Operational Transport Management Plan

Cudgen Lakes
Sand Quarry

Project Approval No. MP05_0103B (MOD2)

January 2025

Figure 1 Traffic Management and Parking.....	8
--	---

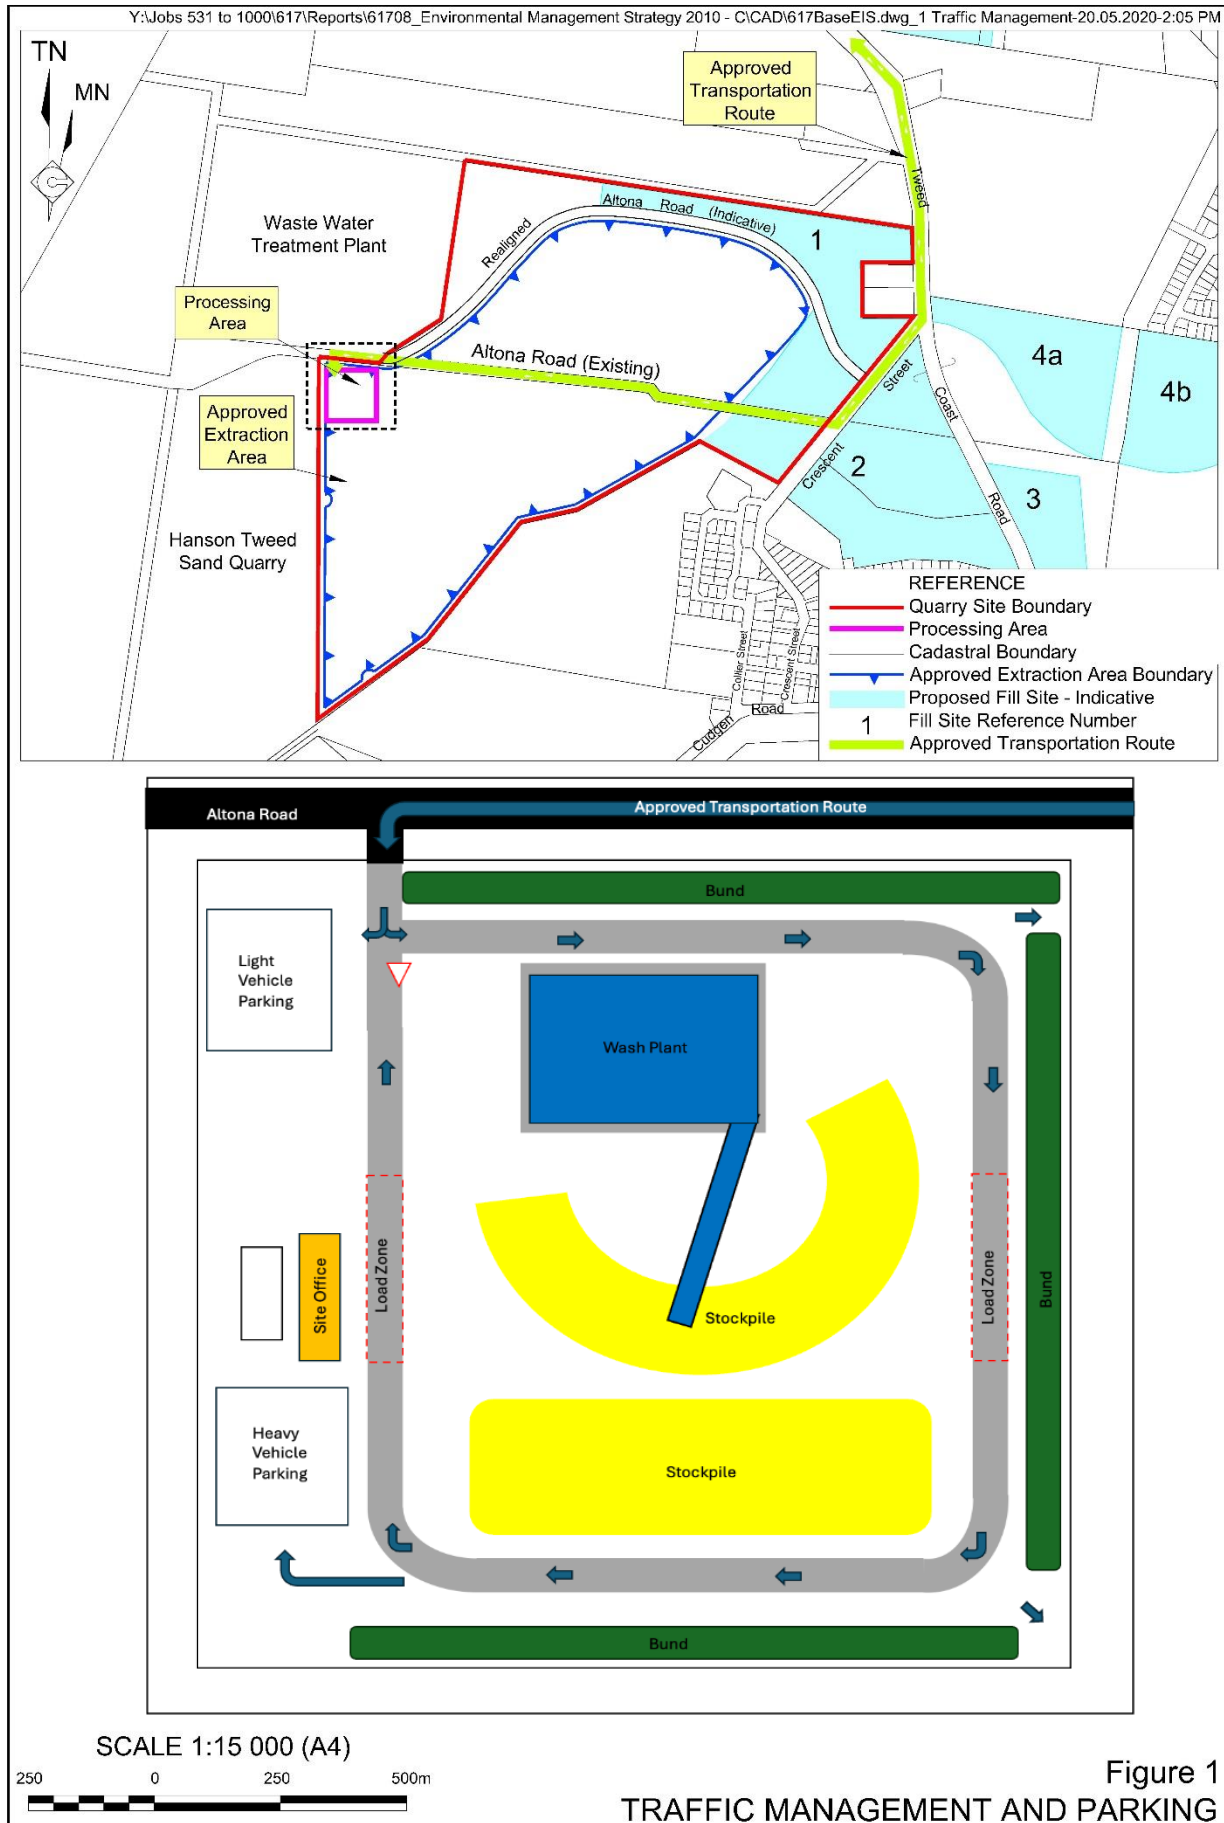
- Exiting truck movements need to be regulated internally by defining their path with physical barriers and signposting to reduce conflicts with entering light vehicles.

Agency	Comment	Coverage
Transport for NSW	Exiting truck movements need to be regulated internally by defining their path with physical barriers and signposting to reduce conflicts with entering light vehicles.	Figure 1 updated to include additional safety barriers which create a defined exit path for trucks. Additional instructional truck signage also included at this defined exit path.
Tweed Shire Council	There are some incorrect references regarding Conditions 3(27) and 3(29) of the MOD 2 consent in section 3 of your document.	Section 3 reviewed and cross references updated as applicable.
	Matters relating to Altona Road upgrades refer to condition 3(27). Matters relating to the Tweed Coast Road – Crescent St intersection relate to 3(29) and this needs to get added to your summary table of applicable traffic conditions.	Condition 3(29) added to Table 1 (Project Approval Requirements Relating to Transportation).
